Access Compliance Report

Public Rights-of-Way

Intersection ID: 29112	Main Street: ARBOR_SPRING_DR	Cross Street: ARBOR_CREEK_DR	Location: N
ADA ID: 637DFB0BF844	Ramp Type: PerpDiag	Initial Pass/Fail: Fail	Overall Compliance: No
		Severity Score: 12.5

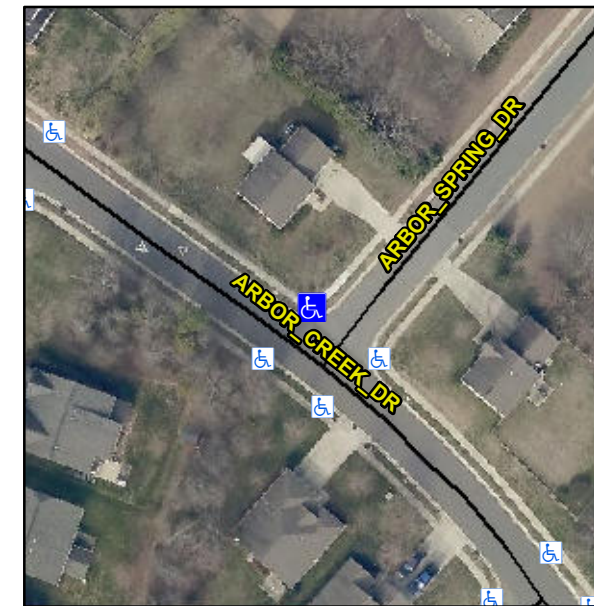
Not Found, R304.5.3

Compliance	Description	Data	Compliance	Description	Data
N/A	Ramp Length (in)	48.0	Yes	Ramp Slope (%)	5.4
Yes	Ramp Width (in)	48.0	No	Ramp XSlope (%)	5.6
N/A	Flare Type LT	N/A	N/A	Flare Type RT	N/A
N/A	Flare Slope LT (%)	N/A	N/A	Flare Slope RT (%)	N/A
N/A	Flare Traversable LT?	N/A	N/A	Flare Traversable RT?	N/A
N/A	Landing Length (in)	N/A	N/A	DWS Provided?	N/A
N/A	Landing Width (in)	N/A	N/A	DWS Contrast?	N/A
N/A	Landing Slope (%)	N/A	N/A	DWS Length (in)	N/A
N/A	Landing X Slope (%)	N/A	N/A	DWS Full Width?	N/A
N/A	Landing Curb? (Y/N)	N/A	N/A	DWS Offset (in)	N/A
N/A	Shared Landing?	N/A			
N/A	Gutter Ponding?	N/A	N/A	Gutter Slope (%)	N/A
N/A	Gutter Lip Ht (in)	N/A	N/A	Gutter X Slope (%)	N/A
N/A	Painted X Walk1?	No	N/A	Painted X Walk2?	No
	X Walk 1 Direction	To SW		X Walk 2 Direction	To SE
N/A	X Walk 1 Width (in)	N/A	N/A	X Walk 2 Width (in)	N/A
	X Walk 1 Slope (%)	3.1		X Walk 2 Slope (%)	0.7
	X Walk 1 X Slope (%)	2.5		X Walk 2 X Slope (%)	4.0

Remove & Replace Curb Ramp With Two New Directional Ramps or Equivalent.
